FDI	ENGINEERING CHANGE ORDER		ECO NO: 09-000.1
			Page 1 of 1
TITLE	DWG NO.	CURRENT REV	NEW REV
ARM7DIMM LPC2478	ARM7DIMM	2.0	2.1

FDI	ENGINEERING CHANGE ORDER		ECO NO: 09-000.2
			Page 1 of 1
TITLE	DWG NO.	CURRENT REV	NEW REV
ARM7DIMM LPC2478	ARM7DIMM	2.1	2.2

FDI	ENGINEERING CHANGE ORDER		ECO NO: 09-002
			Page 1 of 1
TITLE	DWG NO.	CURRENT REV	NEW REV
ARM7DIMM LPC2478	ARM7DIMM	2.2	2.3

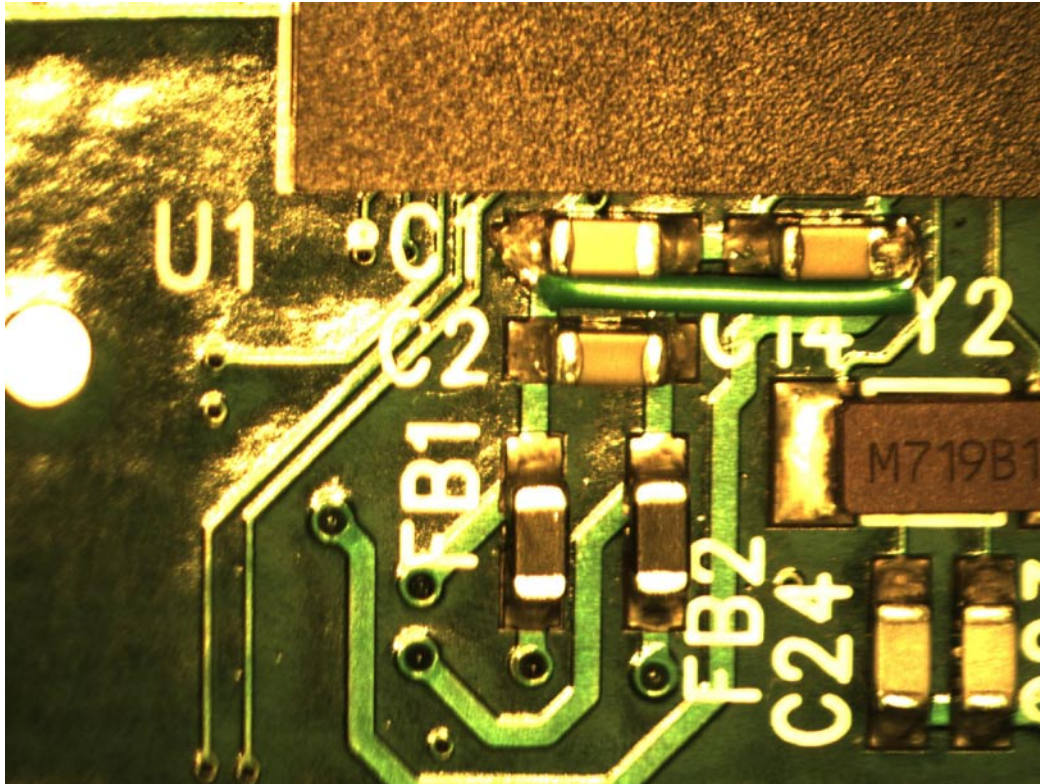
The ADC Vref pin is not connected to a source, hence the ADCs do not function.

1. Add wire from right side of C14 to left side of C1 as shown below;

Reason for change: 1. Correction for Vref connectivity		Disposition/Effectively	
		Use as is	
		Rework to ECO	X
		Scrap & Rebuild	
		Record Change Only	
Prepared by:	M. Hall	Date:	03/27/09
Approved by:		Date:	
Approved by:		Date:	
Approved by:		Date:

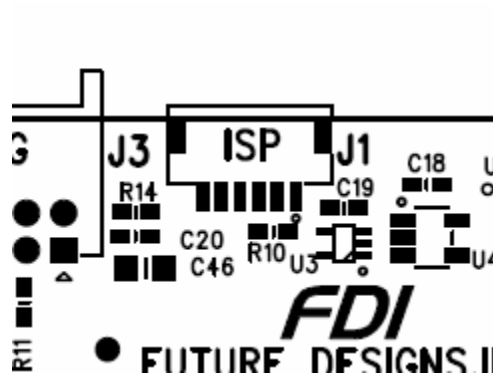
The ISP connector is needed for functional test and ease of customer reprogramming of the CPU

1. Load J1 with FDI PN: J500030 (JST SM06B-SHLS-TF)

Reason for change: 1. Load J1		Disposition/Effectively	
		Use as is	
		Rework to ECO	X
		Scrap & Rebuild	
		Record Change Only	
Prepared by:	M. Hall	Date:	03/27/09
Approved by:		Date:	
Approved by:		Date:	
Approved by:		Date:

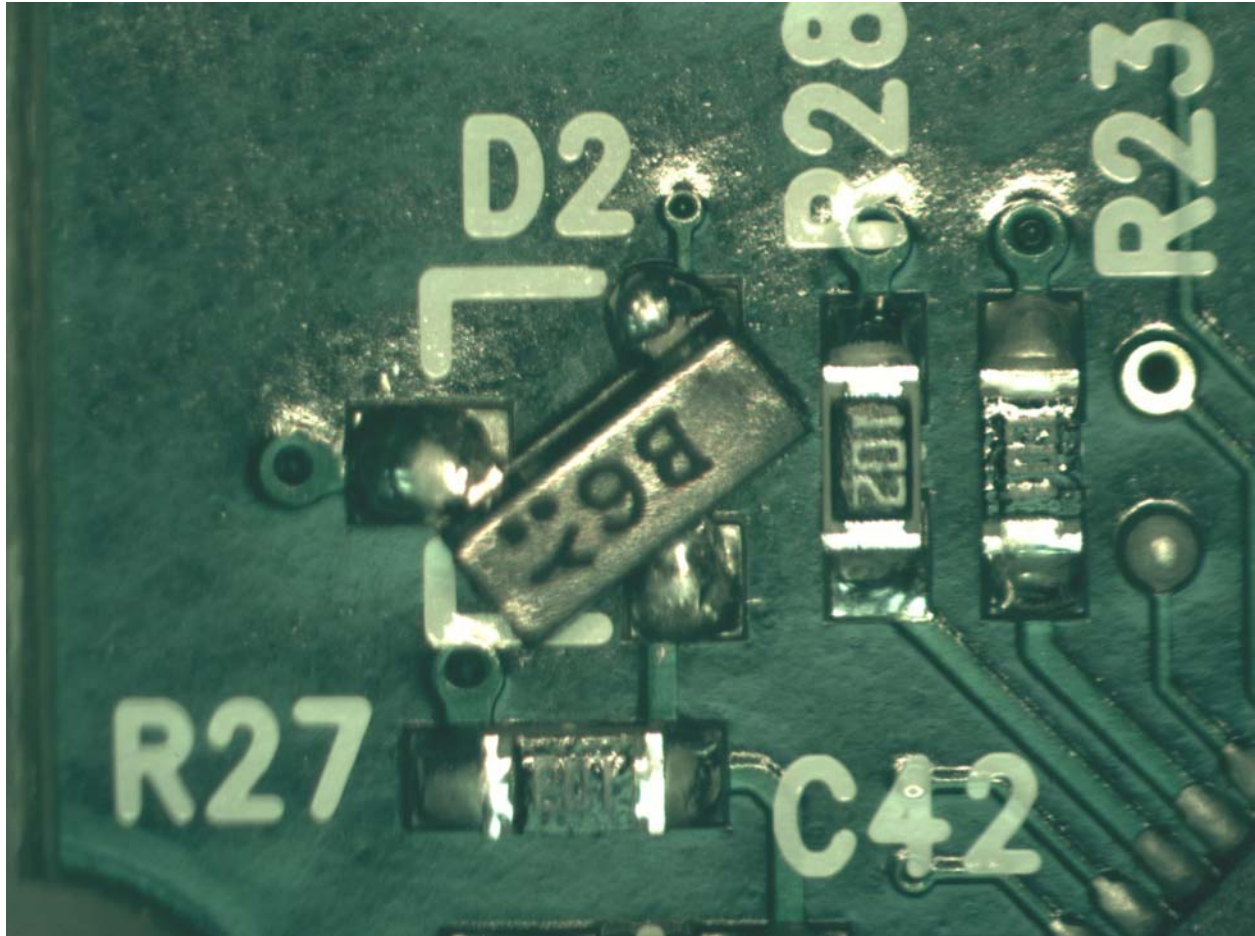
The Ethernet PHY was intermittent and would powerup at different addresses. It was determined that the reset circuit was not functioning properly due to improper footprint for D2.

1. Rotate D2 diode 120 degrees counter-clockwise

Reason for change: 1. Correction for incorrect SOT23 footprint of D2		Disposition/Effectively	
		Use as is	
		Rework to ECO	X
		Scrap & Rebuild	
		Record Change Only	
Prepared by:	M. Hall	Date:	03/27/09
Approved by:		Date:	
Approved by:		Date:	
Approved by:		Date:
